Draft determination of causer: 23 October (5.42pm) 2025 UFE

Consultation paper

An under-frequency (UFE) event occurred on 23 October 2025 at 5.42pm. The purpose of this paper is to set out the Electricity Authority Te Mana Hiko's (Authority) draft determination of causer for the UFE. It invites feedback from affected industry participants on the draft determination of causer and the System Operator's calculation of megawatts of power lost during the event.

- (h) the frequency was restored to normal by 5.43pm.
- 3.5 The Authority has produced the diagram in Figure 1 to show the double circuit line and the circuit affected by this UFE.

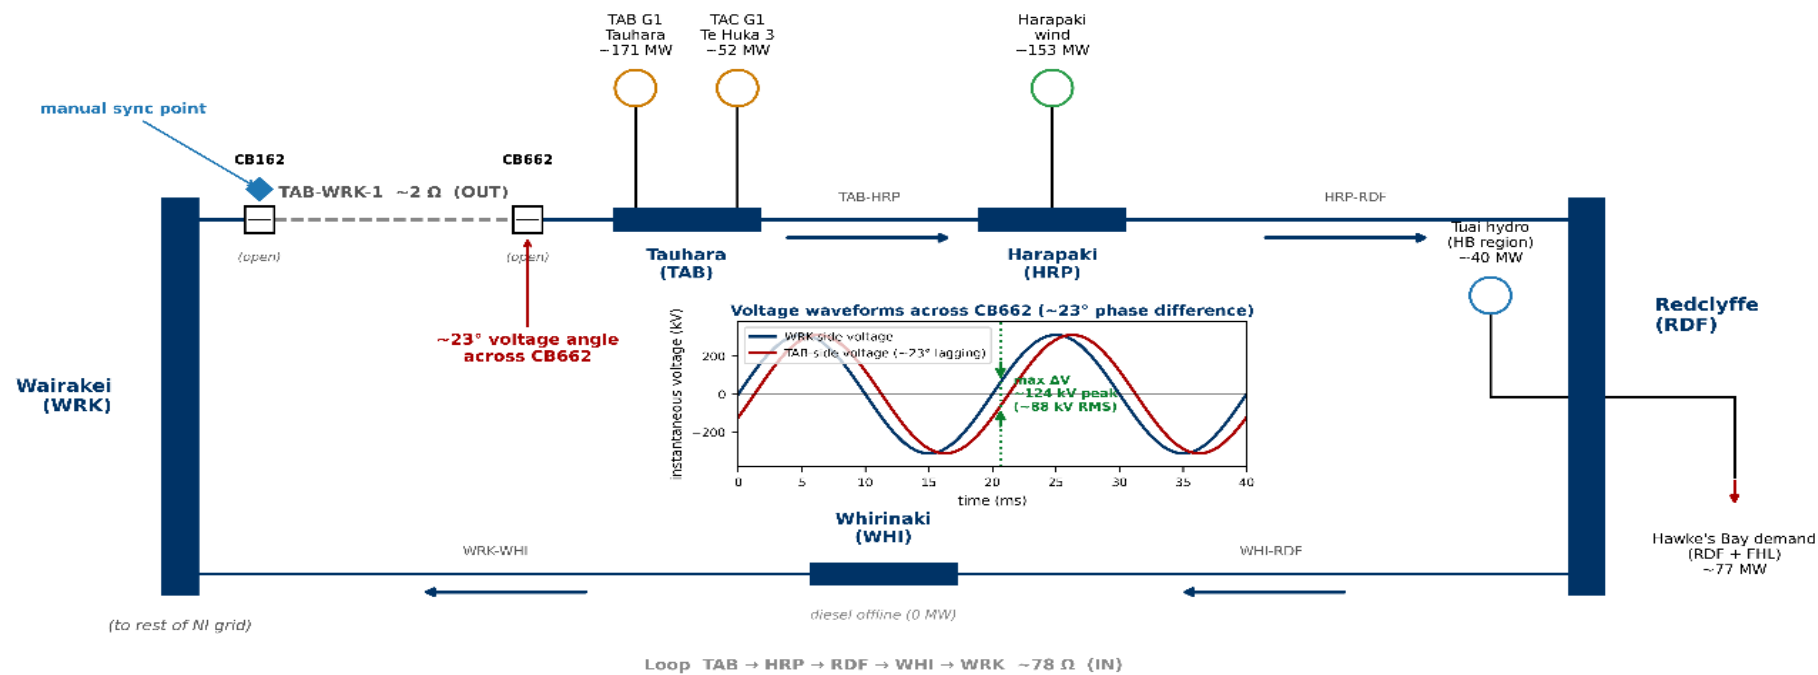
- (a) immediately prior to the UFE, the Tauhara-Wairakei-1 (TAB-WRK-1) circuit was out of service on planned outage
 - (b) with TAB-WRK-1 out of service, the impedance between TAB and WRK through the parallel Hawke's Bay loop was approximately 78 ohms, but with TAB-WRK-1 in service it is approximately 2 ohms

- (d) at approximately 5.42pm, TAB-WRK-1 was ready to be returned to service
 - (e) the breaker at the Wairakei end (CB162) was closed, energising the circuit, and then the breaker at the TAB G1 end (CB662) was closed

- (f) immediately before CB662 was closed, the voltage angle across the open breaker contacts was approximately 23 degrees
 - (g) within seconds of CB662 closing, TAB G1 and TAC G1 both tripped, causing the system frequency to drop to a minimum of 49.2Hz
